Pilot Test Report Comments

**TECHNICAL COMMENTS ON
DRAFT
REPORT TO
CHEROKEE COUNTY SITE
PARTICIPATING PRPs**

**PILOT LEACH TESTING
GALENA SUBSITE, KANSAS**

prepared by
Adrian Brown Consultants, Inc.
Dated: June 30, 1989

Figure 1
Partial Batch Test Results for Lead
(After/Before)

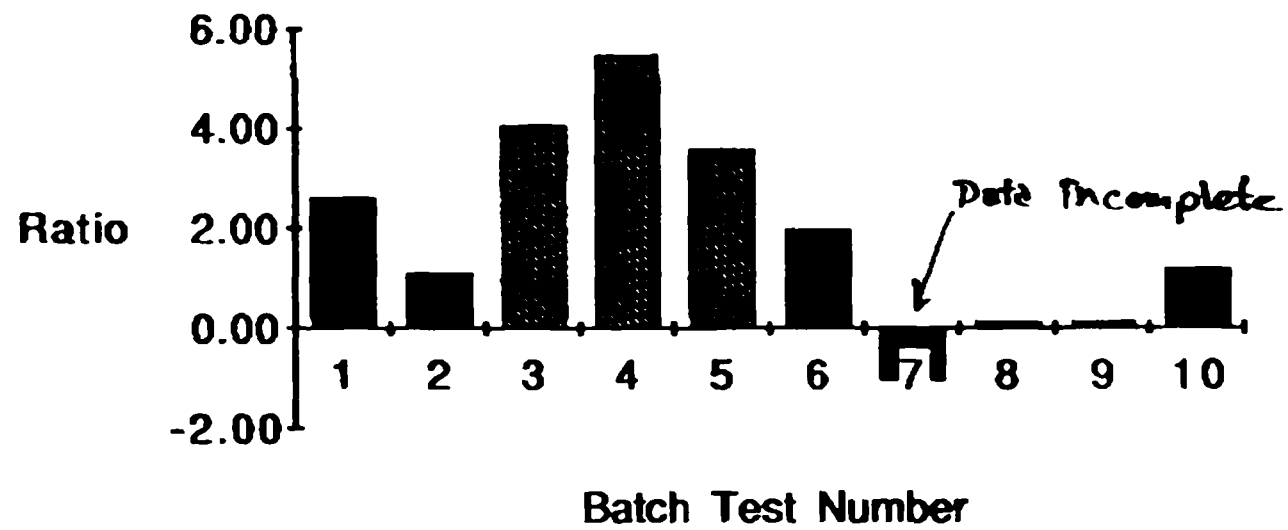
4. The batch test data are treated as a lump without looking at the individual tests. The attached graph (Figure 1) shows that the two unscreened and the single minus 2 inch batch tests leached more lead (Pb) than the other batch tests. These ratios are shown as tests 3, 4, and 5 on the figure (ratios are crosshatched to highlight them). Table 1 presents the ratio calculation bases for Figure 1.

The EPA disagrees with the basic conclusion of the ABC report that says that screening of the mine waste rock is unneeded for the selective backfill remedy. The batch test data show clearly excess lead leaching from the minus 2 inch materials and the unsorted materials (refer to Figure 1 attached).
